Title & Document Type: **8405A Vector Voltmeter Operating and Service Manual**

Manual Part Number: **08405-90024**

Revision Date: **May 1971**

8405A

Figure 7-6(b). Schematic Diagram. RF Sampling Section

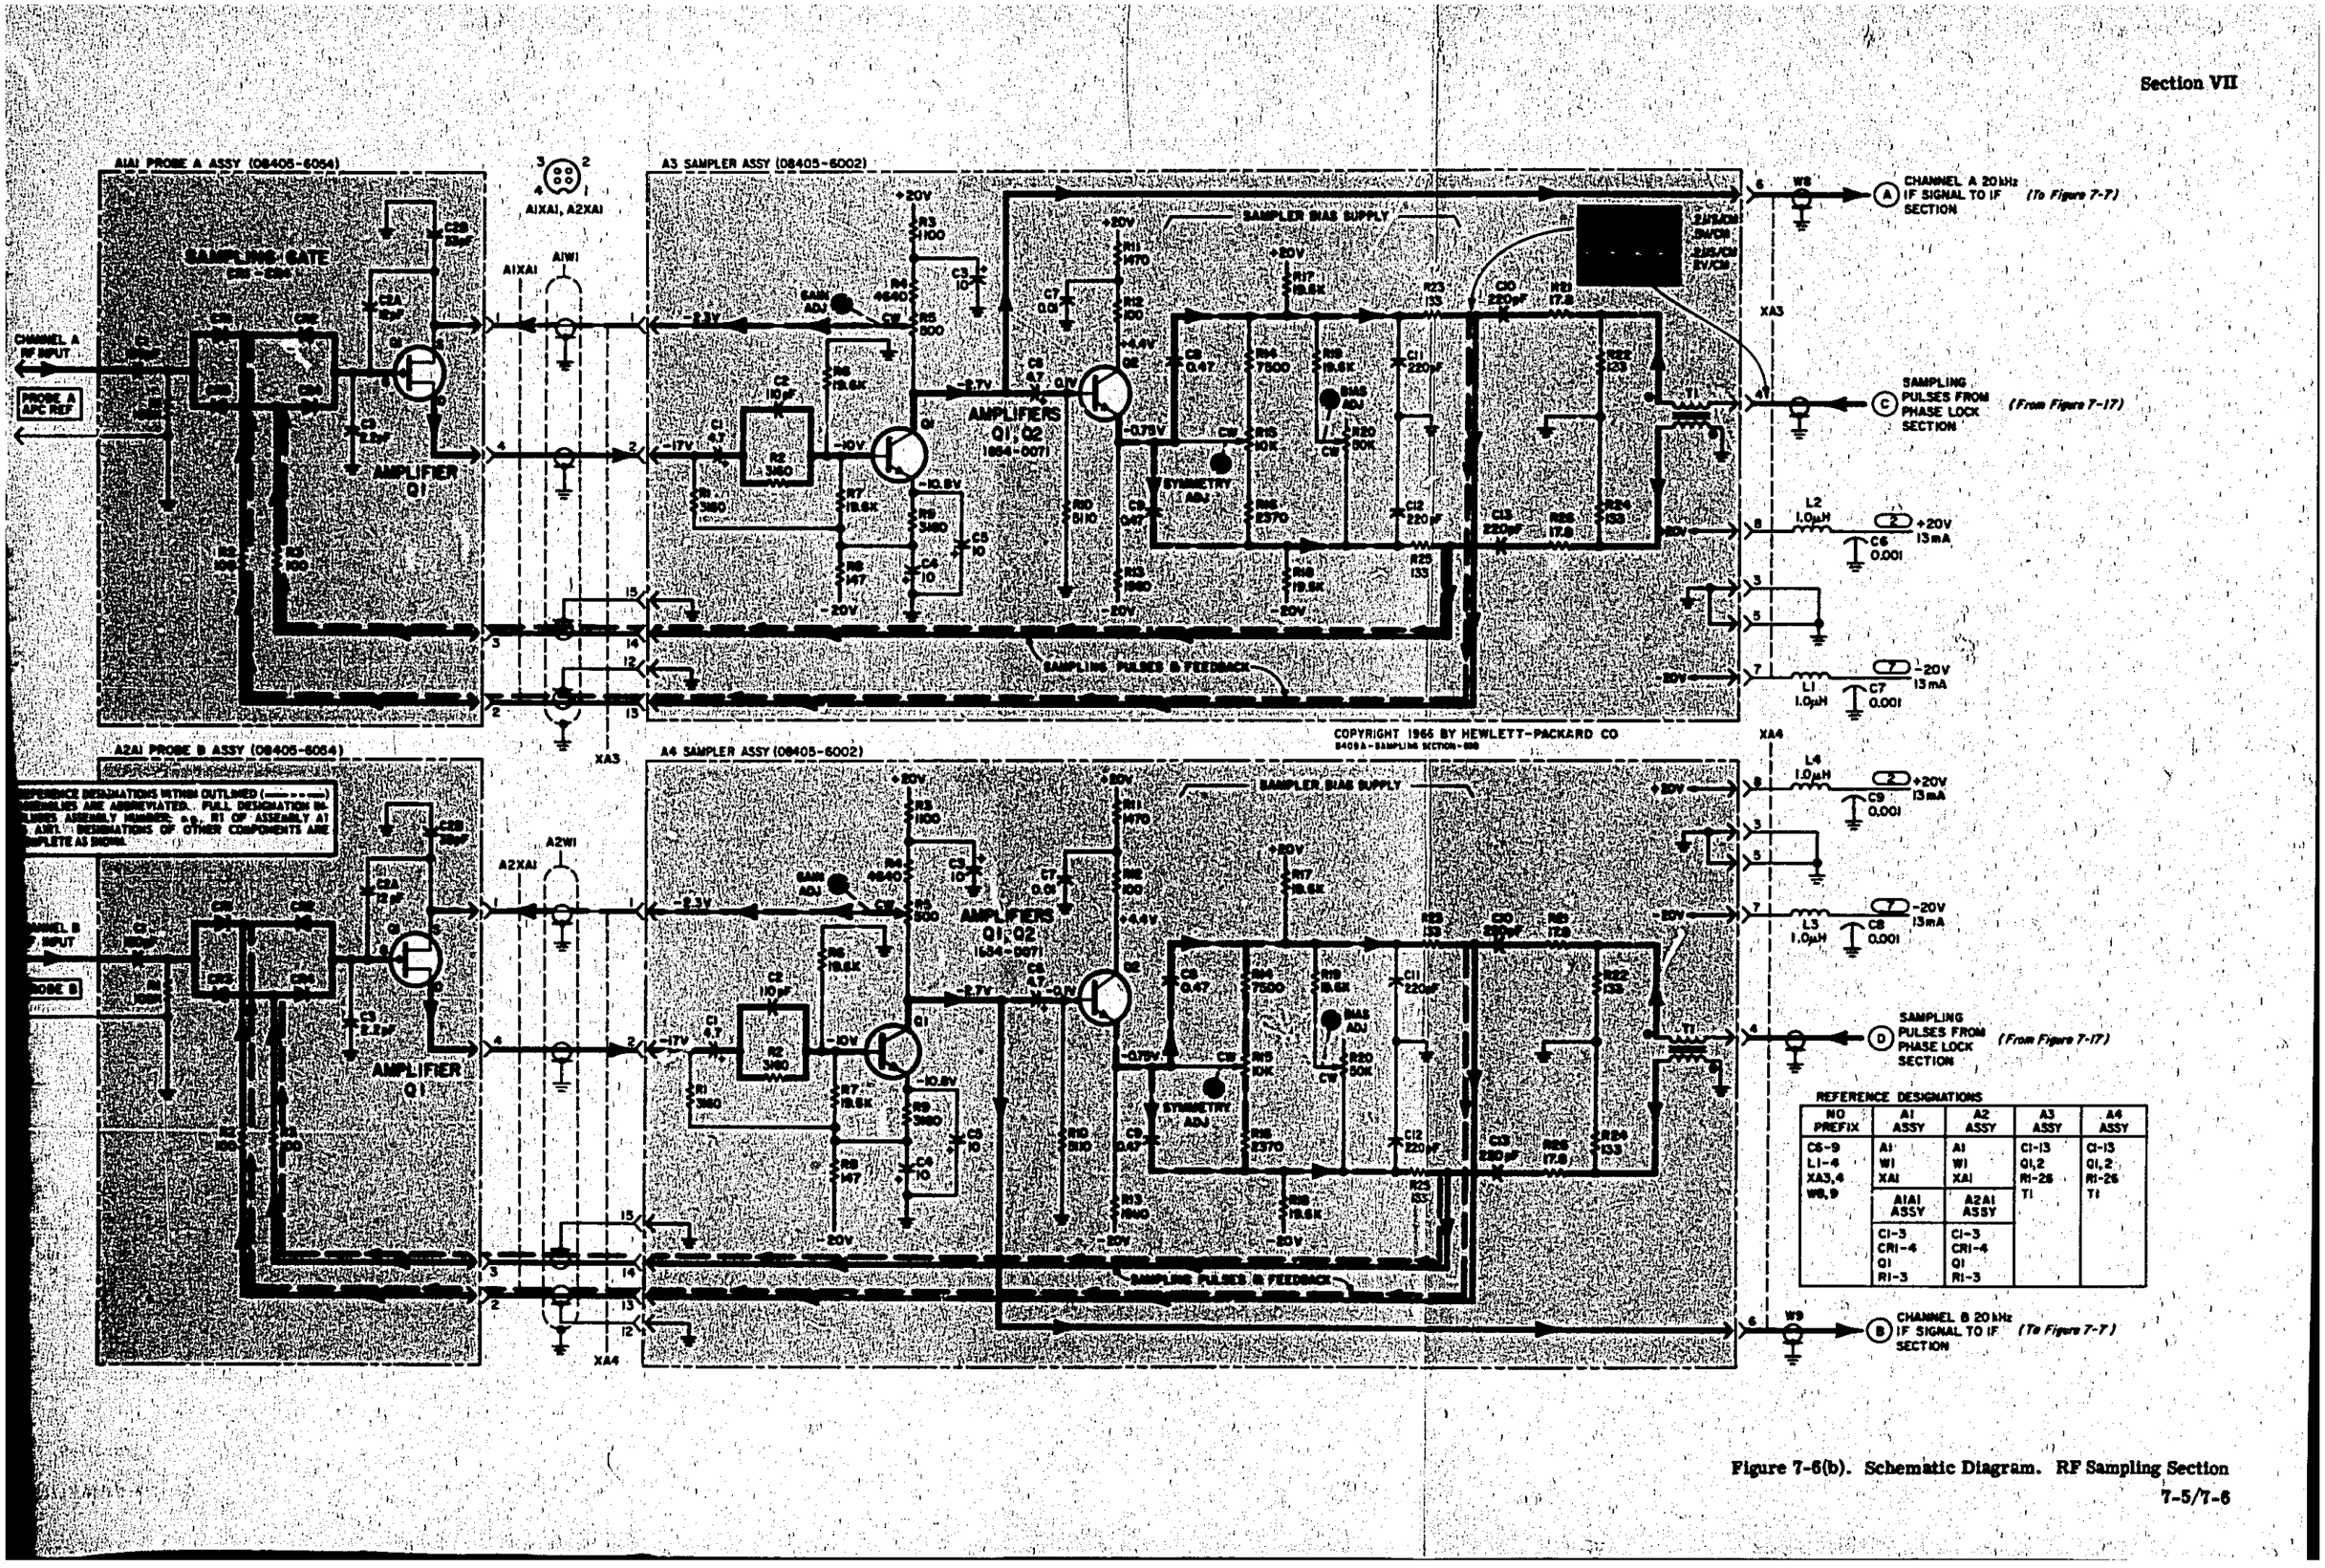
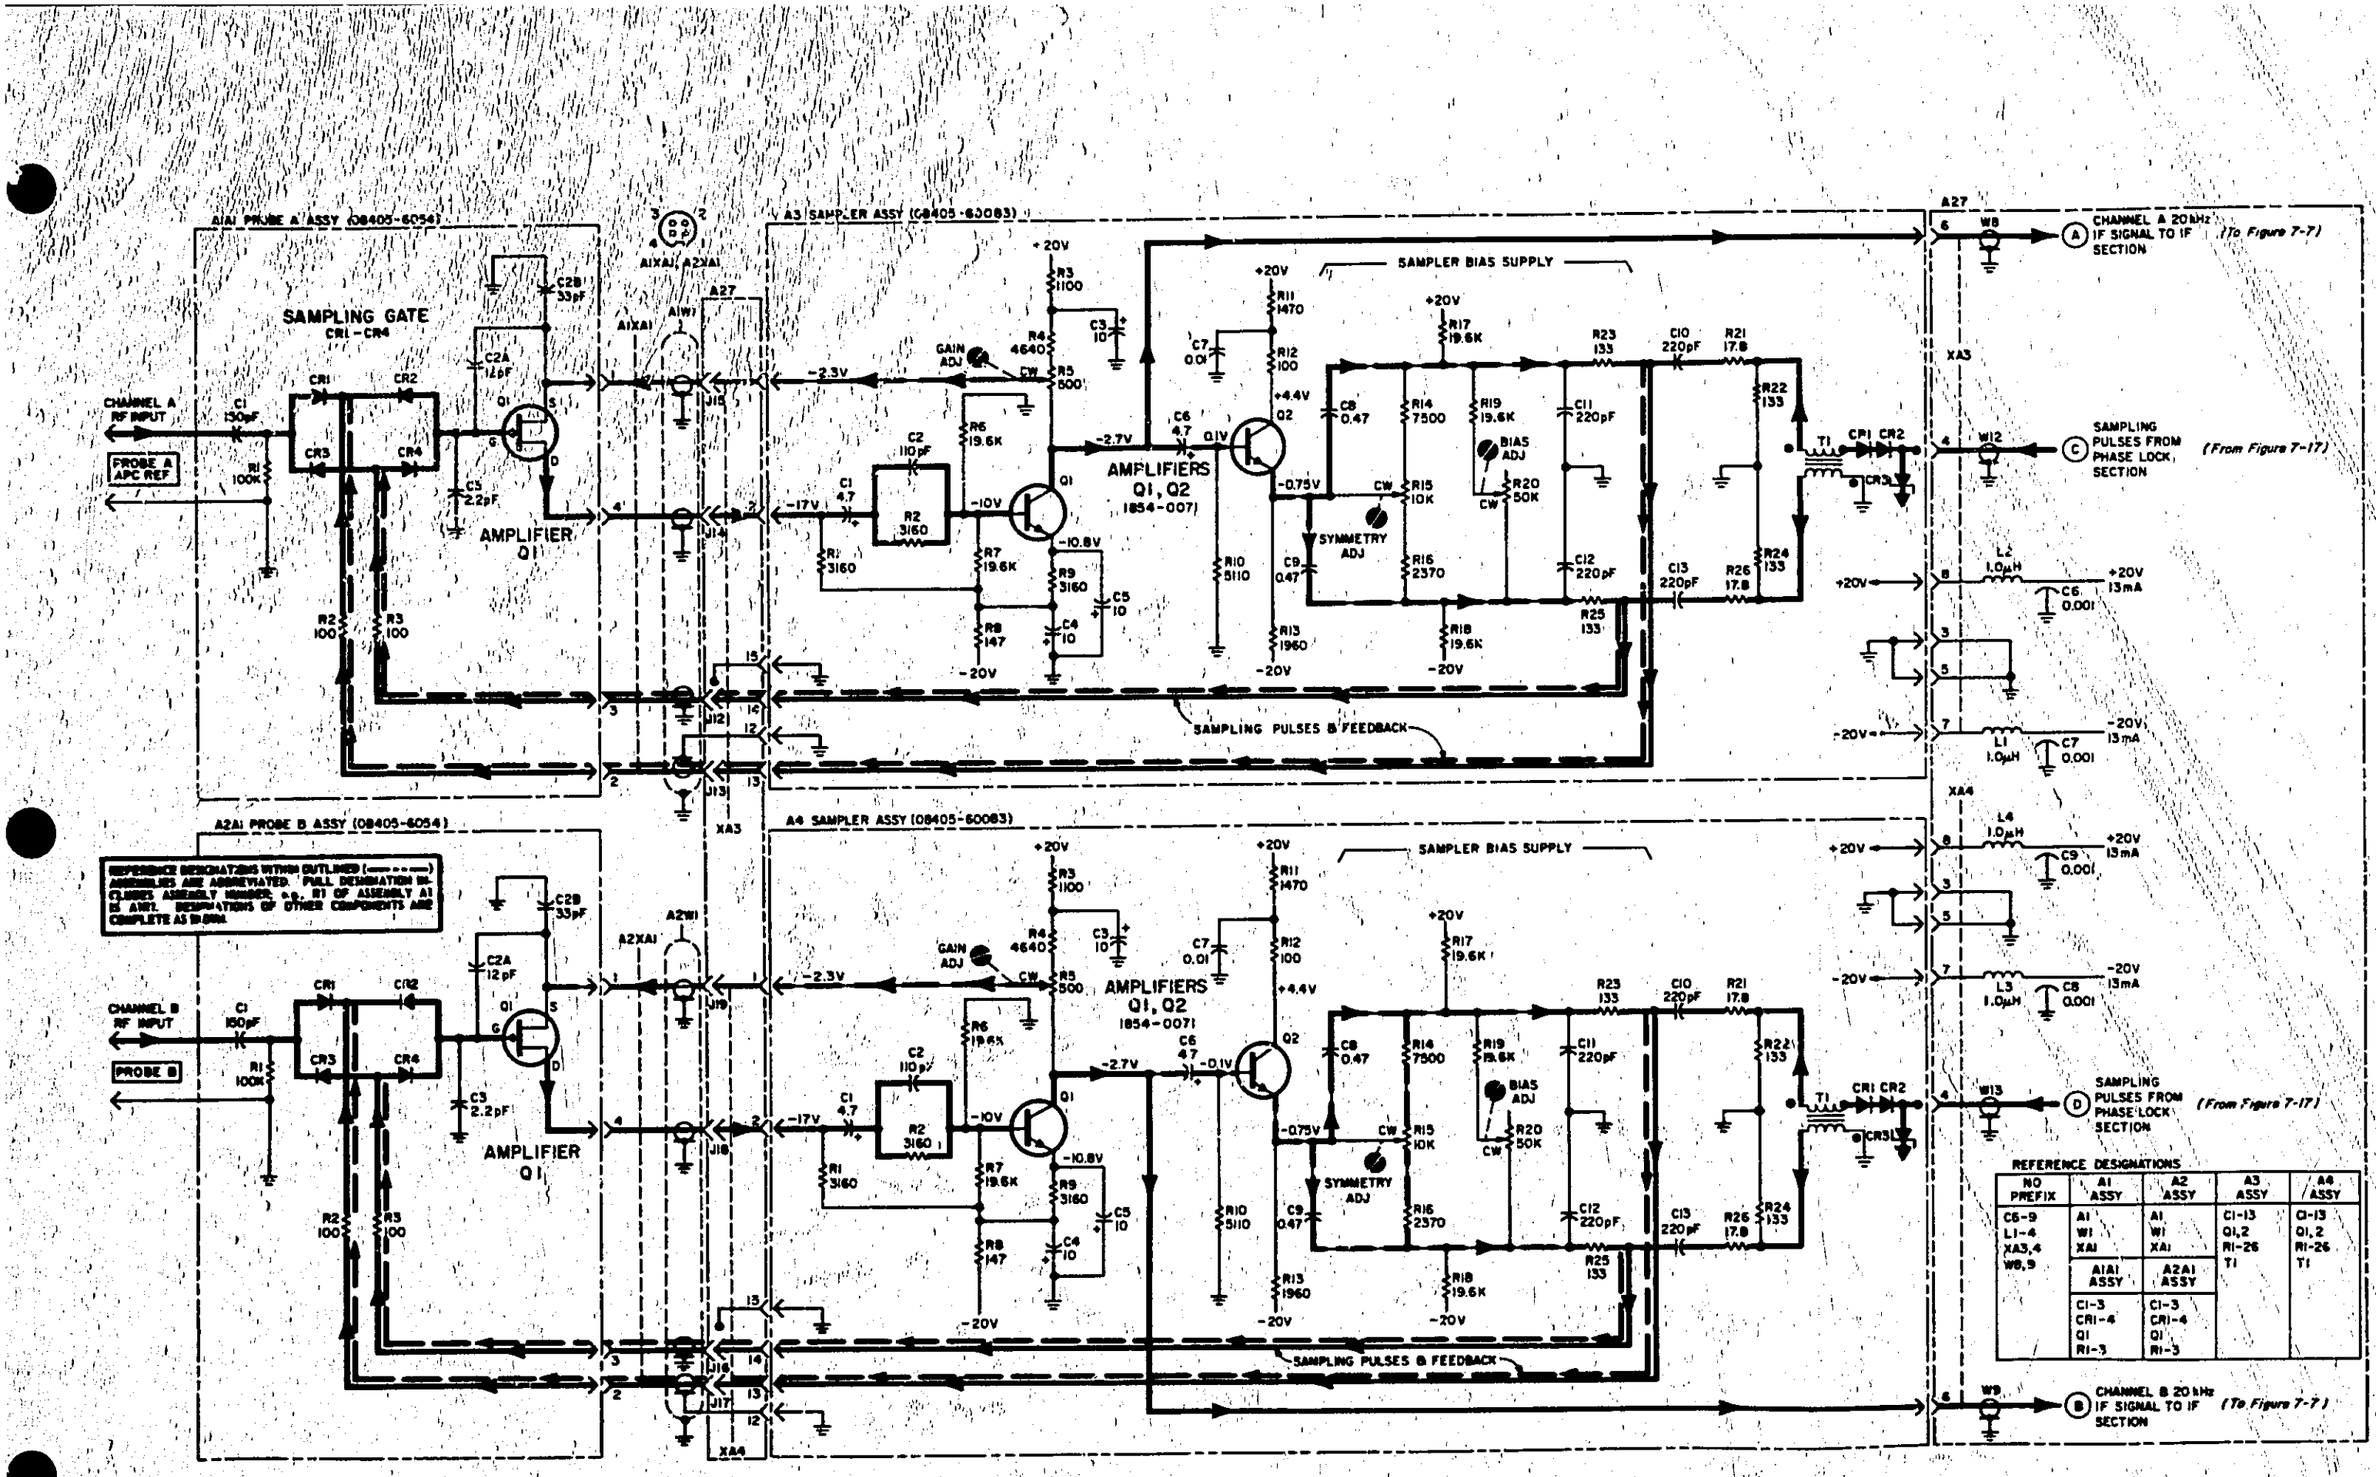
Figure 7-5(b): Change value of A3R21 and A3R26 to 16.7 ohm.

PAGE 7-5:
Figure 7-6(b):
Change value of R21 and R26 to 16.7 ohm.

Figure 7-6(b): Replace Figure 7-6(b) with Figure 7-6(b) in this change sheet (CHANGE 17).
